ENCLOSURE 1

EVALUATION OF THE ERROR AND PROPOSED PATH FORWARD

SUMMARY OF CHANGES TO SAFETY ANALYSIS REPORT FOR PACKAGING: THE ORNL HFIR UNIRRADIATED FUEL ELEMENT SHIPPING CONTAINER

**SAFETY ANALYSIS REPORT FOR PACKAGING
THE ORNL HFIR UNIRRADIATED FUEL
ELEMENT SHIPPING CONTAINER
VOLUME I**

Fig. 1 Fuel Elements as Bent and Inserted Into Side Plates

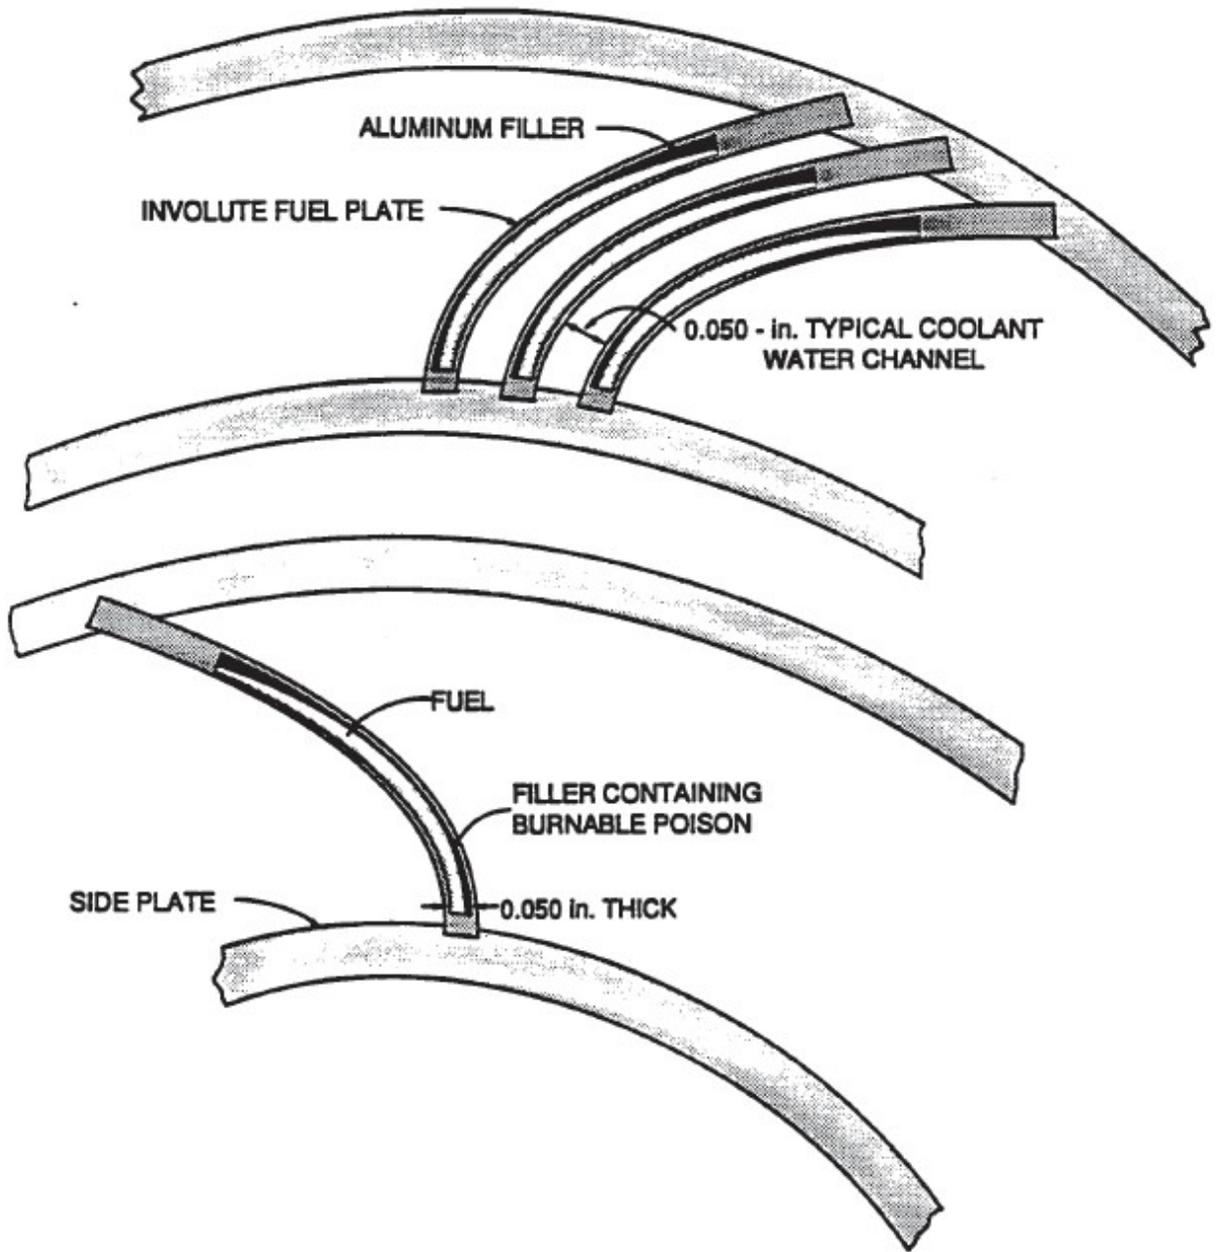
The fuel plates are 24 in long. The fuel-bearing portion of the plates is 20 in. long. Figure 1 shows a schematic of the fuel plates as they are inserted into the side plates.

FIG. 3. SCHEMATIC OF INNER PLATE

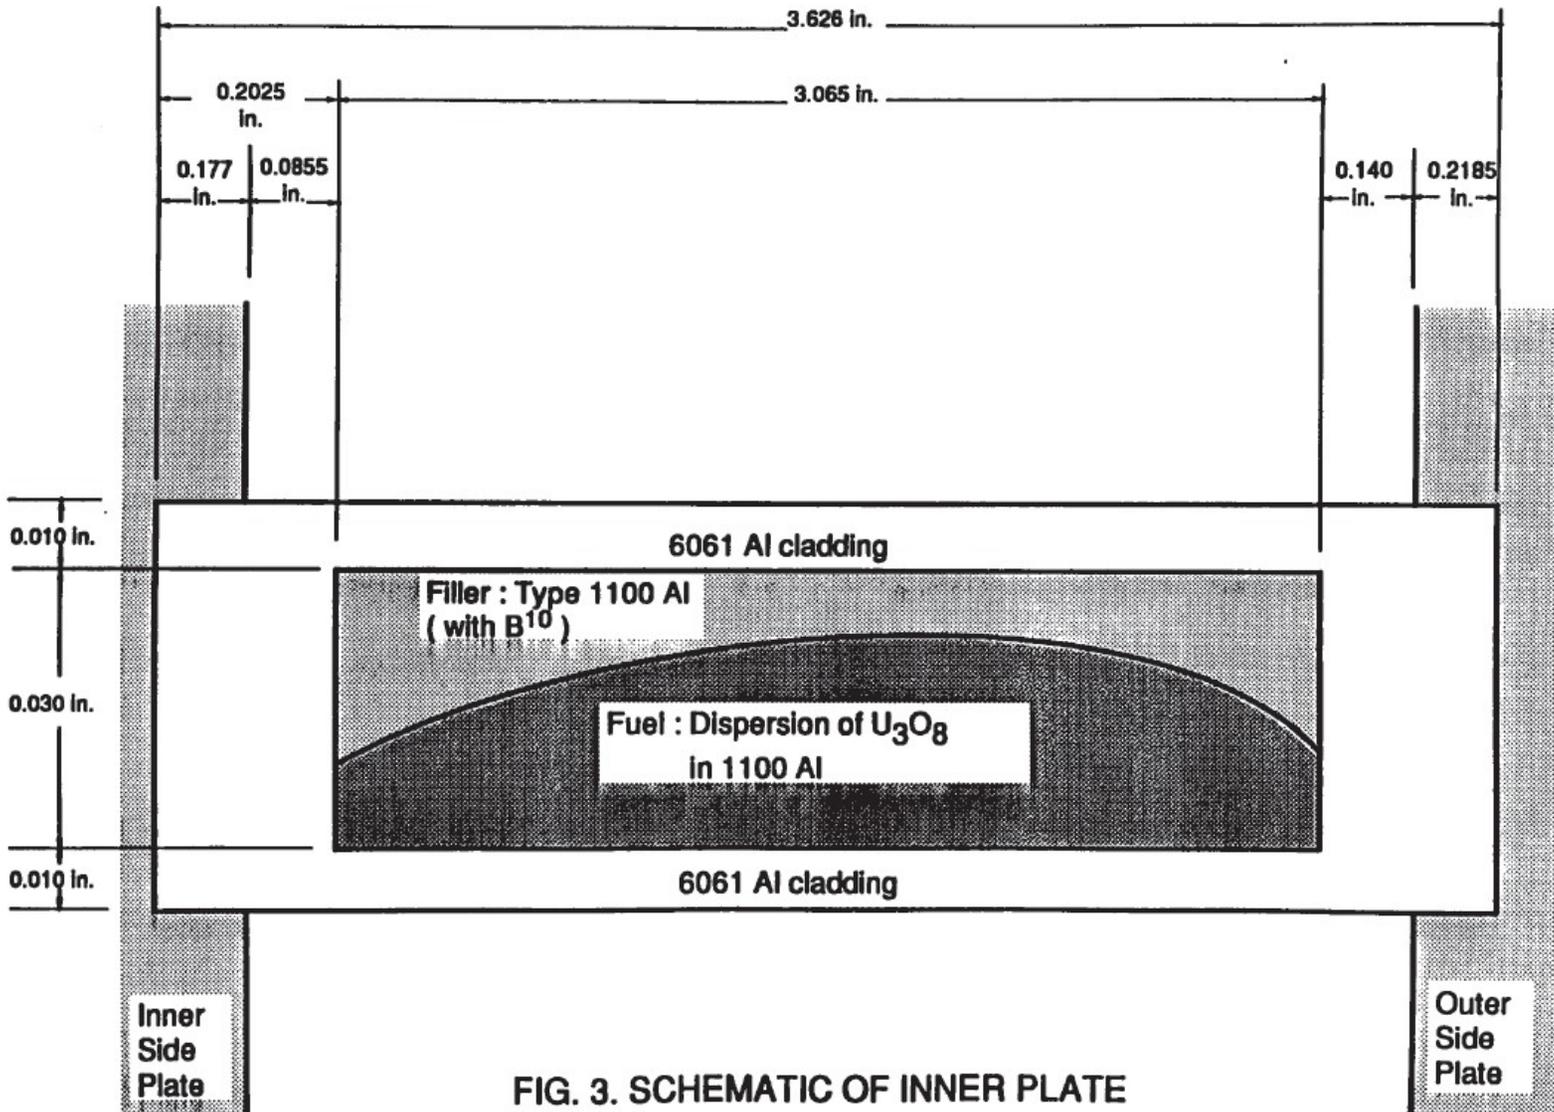
A schematic of an inner fuel plate drawn as if it were flat is shown in Fig. 3. The dimensions of the plate are given in ref. 7 and those of the side plates in the inner fuel element drawing (Chapter 1, Fig. 1.7). The dimensions shown in fig. 3 are the averages of the maximum and minimum values. All dimensions are rounded to the even half mil (0.0005 in).

The side plate for the inner assembly is 0.105 in thick. The erosion of 0.105 in of aluminum side plate at 1.90 in/hr requires

In addition, the fire must erode a width of 0.140 in of exposed plate which has no fuel before reaching the fuel-bearing portion. The appropriate erosion rate is the cladding value doubled, or 3.8 in/hr. This additional erosion requires

During this time interval, the erosion in the inner plates (using the 1.63 in/hr rate) will be
erosion inner element = 0.41 hr x 1.63 in/hr = 0.668 in

$$L \text{ total inner element} = 3.065 \text{ in}$$

$$0.668 / 3.065 = 21.8\%$$
